EFM OAM

Schedule and Work Plan

Matt Squire
Hatteras Networks
January, 2003

EFM OAM Status

OAM Client Parser Controls

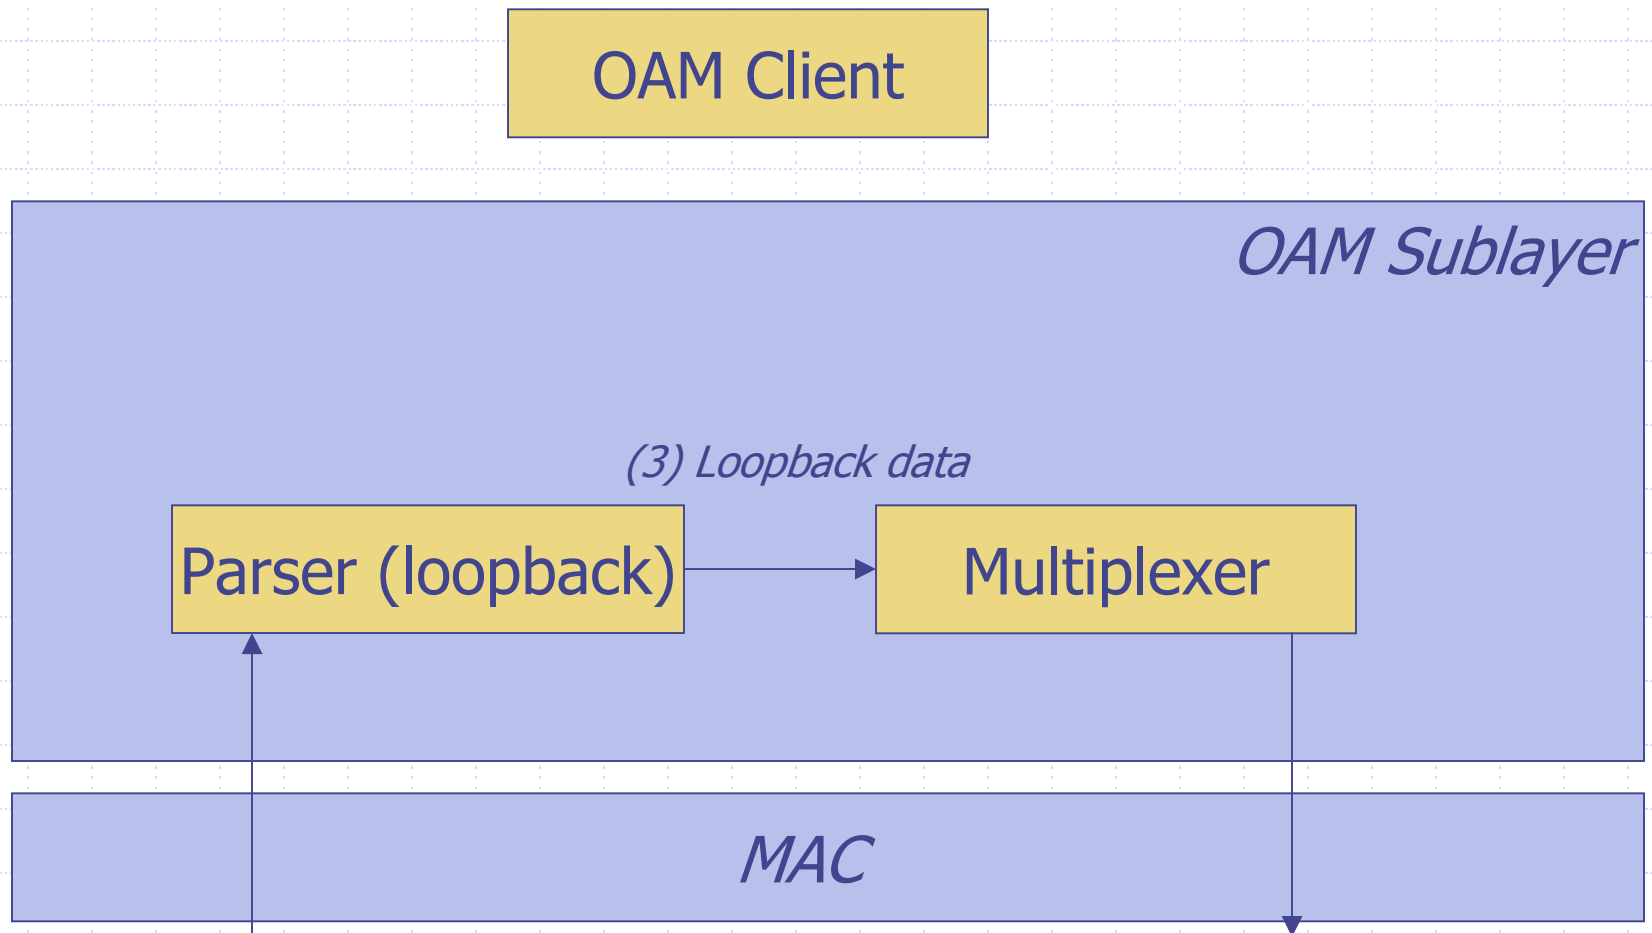
- OAM Client receives loopback request and puts the parser in loopback mode

- In loopback mode, parser passes non-OAM frames to multiplexer

OAM Client Parser Controls

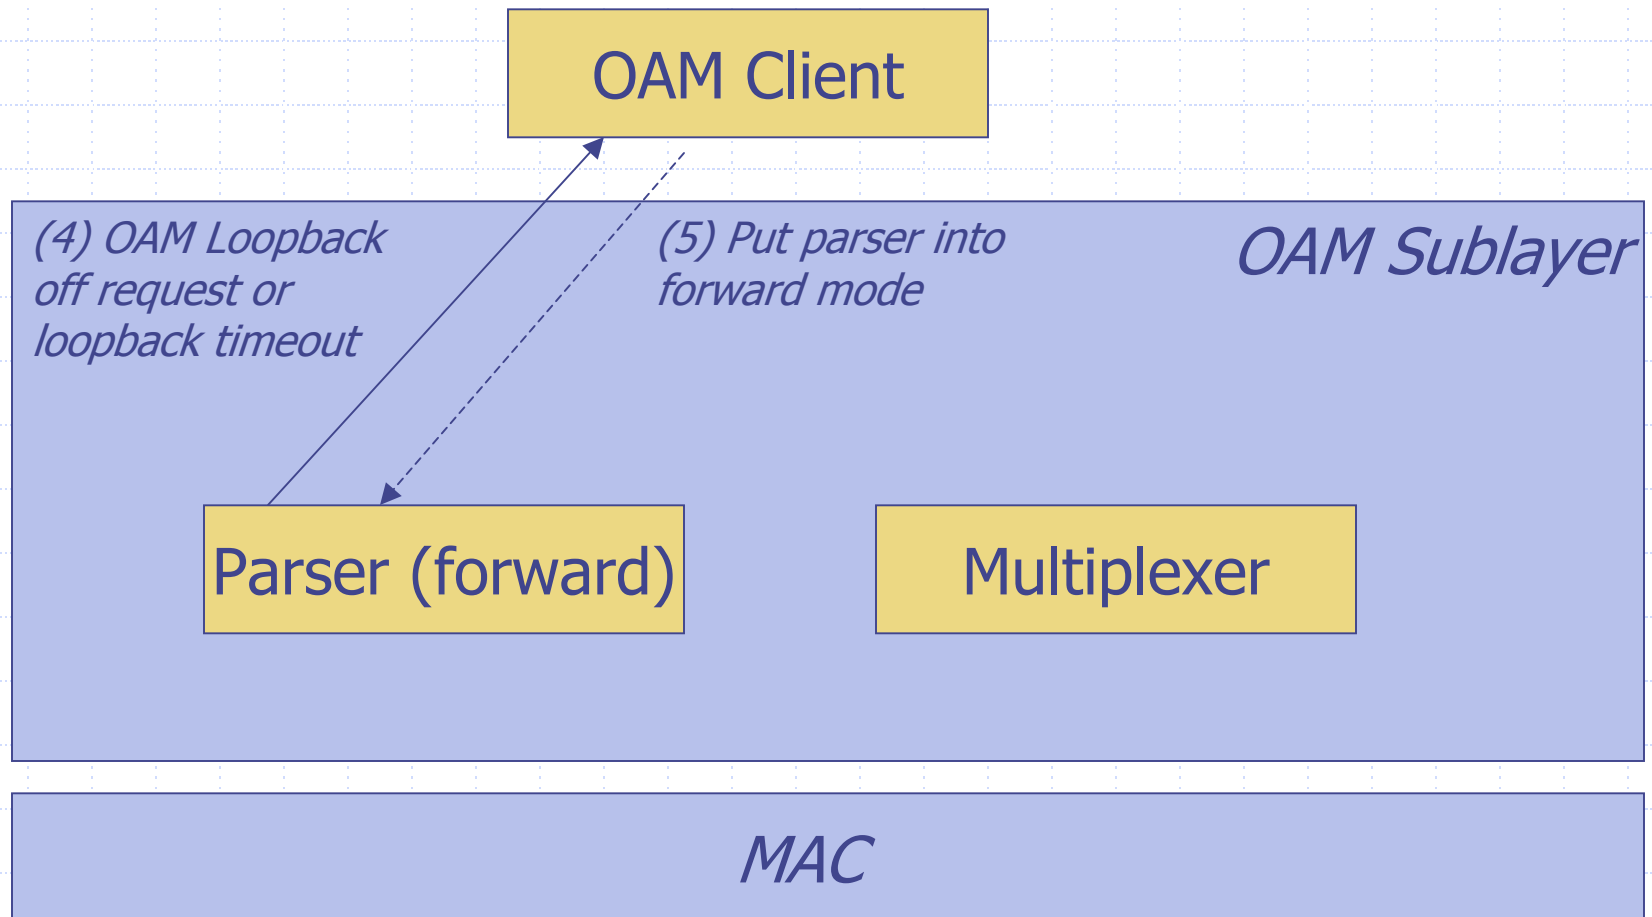
- OAM Client again controls exit out of loopback by telling parser to return to forward state
